Vauxhall Vivaro, Renault Traffic & Nissan Primastar SWB Models

CATB 0004

FKB3252 - Modified Brake Cable

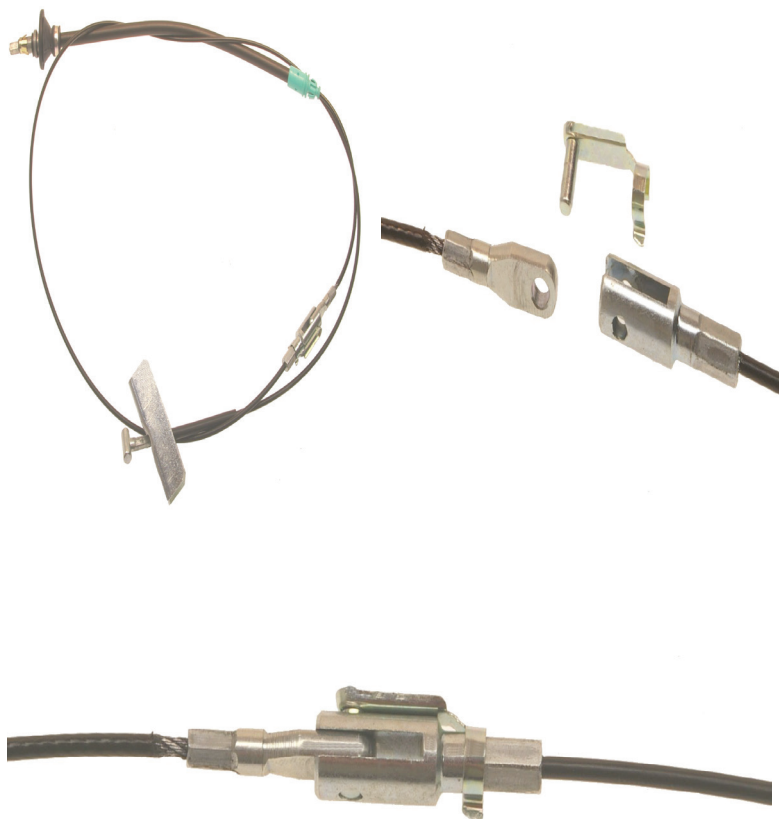
MY 2001 - 2010 With a newly modified fixing to alleviate the problem of the front to intermediate cable fixing breaking, this is in line with the O.E conversion kit supplied by the manufacturers.

The replacement cable is supplied with all necessary fittings to allow correct routing of the cable. This is important as an incorrectly routed or fitted cable will not perform correctly and could lead to an accident.
